CONSERVATION TEAM CONSULTATION APPLICATION RESPONSE

APPLICATION REF:	26/01136/FPH & 26/01137/LBC
CASE OFFICER:	VW
APPLICATION SITE:	83 High Street, Barkway, Royston, Hertfordshire SG8 8ED
DESCRIPTION OF WORKS:	Installation of no.8 rear and side windows and one French door to rear with energy-efficient timber-framed windows with vacuum insulated glass (VIG) to replace existing no.8 rear and side windows and rear French door.

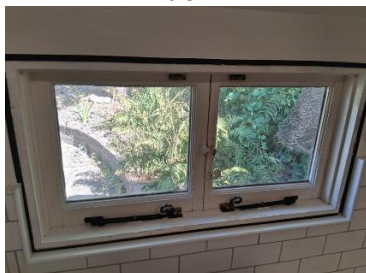
In the case of openings 2, 4, 5, 6, 8 & 9, it is considered that the existing windows fall within the second category of Historic England's general approach above i.e. replacement windows whose design follows historic patterns and make a positive contribution to the significance of the listed building. As such, the guidance implies that such windows should be retained and repaired where possible. If beyond repair, they should be replaced with accurate copies. Whilst criteria 5 says that where the aesthetic value of the building is high, then the impact on the whole of the relevant elevation should be considered, including the desirability of accurately matching other windows. If some form of double-glazing is to be considered acceptable consideration should be given to the cumulative effect of these differences to see if the replacement windows would or would not be appreciable as obviously modern fixtures.

Window 5

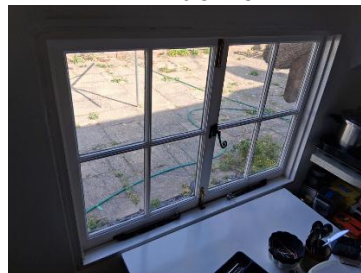
Point 2 – Existing windows 5 and 9 are pairs of quarter-pane casements (L5 measuring 850mm high x 1205mm long whilst L9 measures 880mm high x 1125mm long.) Both windows are shown to receive pairs of 6-pane casements similar to window 4. However, window 4 measures 925mm high x 935mm long i.e. taller and narrower when compared with windows 5 and 9. Whilst the proposed drawings look to be acceptable in terms of pane proportions (albeit the panes are more 'square' compared with the panes at window 4), considering that the existing left and right-hand rear dormers are to remain as quarter-pane windows, I query whether windows 5 and 9 would look better as existing i.e. fewer glazing bars and where it is also noted that there are two existing pairs of quarter-pane casements on the front elevation.

Please see comment regarding windows 5 & 9 above, otherwise, I find this proposal **UNOBJECTIONABLE**.
